DEVELOPMENT APPLICATION ASSESSMENT REPORT

Application Number:	DA2020/1759
----------------------------	-------------

Responsible Officer:	Anne-Marie Young
Land to be developed (Address):	Lot 2 DP 233083, 51 Arthur Street FORESTVILLE NSW 2087
Proposed Development:	Demolition works and construction of a shop top housing development
Zoning:	Warringah LEP2011 - Land zoned B1 Neighbourhood Centre
Development Permissible:	Yes
Existing Use Rights:	No
Consent Authority:	Northern Beaches Council
Delegation Level:	NBLPP
Land and Environment Court Action:	No
Owner:	Gabrielian Holdings Pty Ltd
Applicant:	Gabrielian Holdings Pty Ltd

Northern elevation (source Ramsay Architects)

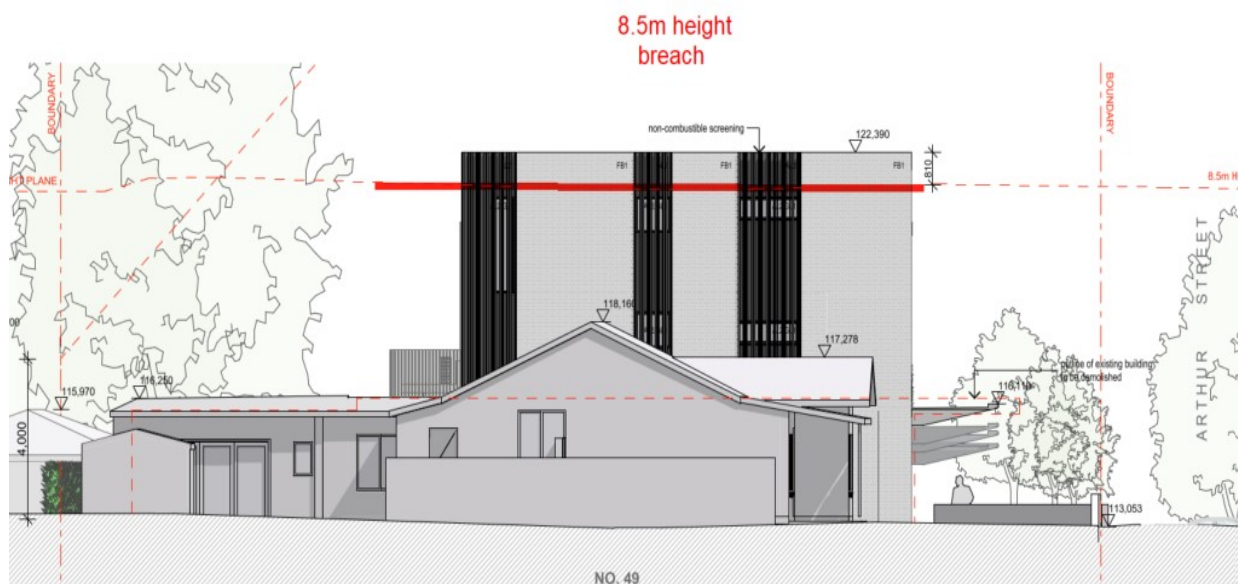
The proposal will result in a height of between 9.7m and 10.4m which equates to a breach of the height control of 14.6% - 22.4% as illustrated in the diagrams below:

The applicant's argument that the proposed design provides an appropriate contextual response to the surrounding area is not supported. The excessive height, bulk and scale and insufficient set backs of the upper floor to the eastern boundary results in a development that lacks any transition to the low density scale of the adjoining single storey dwelling at No. 49 Arthur Street. The excessive height is emphasised with the vertical louvres along the eastern elevation. In addition the site is constrained by its topography and fall across the site from east to west and north to south. The impacts of the development at the western boundary are amplified due to this constraint.
